Delegated Decisions by Cabinet Member for Transport

CABINET MEMBER FOR TRANSPORT – 5 JANUARY 2012 YARNTON RUTTEN LANE ZEBRA CROSSING

Report by Deputy Director for Environment & Economy (Highways & Transport)

ANNEX 2

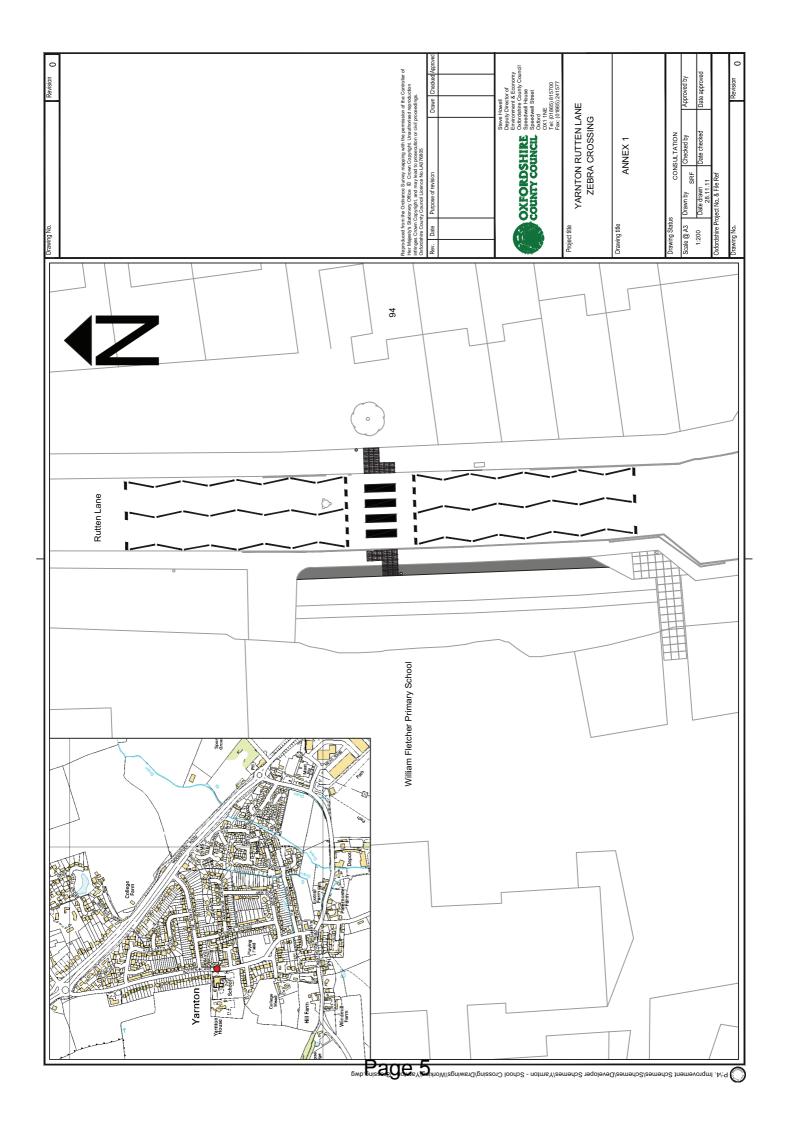
Respondent	Support proposal	Comments	Officer Comments
Resident, Rutten Lane	N	Crossing should be located at the existing pedestrian access to the primary school	Crossing points directly in line with the adjoining pedestrian route could lead to children of primary school age running straight out into the carriageway.
		Concerns were expressed at any additional lighting (lots had gone in at the access road to the nearby nursing home).	Two combined street lighting columns/belisha beacon assemblies will be required. Hoods will be fitted to restrict illumination to the highway and minimise impact on nearby properties.
		Frontagers to the crossing park vehicles on their front gardens.	This activity occurs but most do not have legal access via dropped kerbs.
Oxfordshire Unlimited	Y	No objection to the crossing but request that adjacent footways are wide enough to accommodate a wheelchair user or a blind person with guide dog.	Agree. The footway to the west, between the primary school and the nursing home, will be widened.
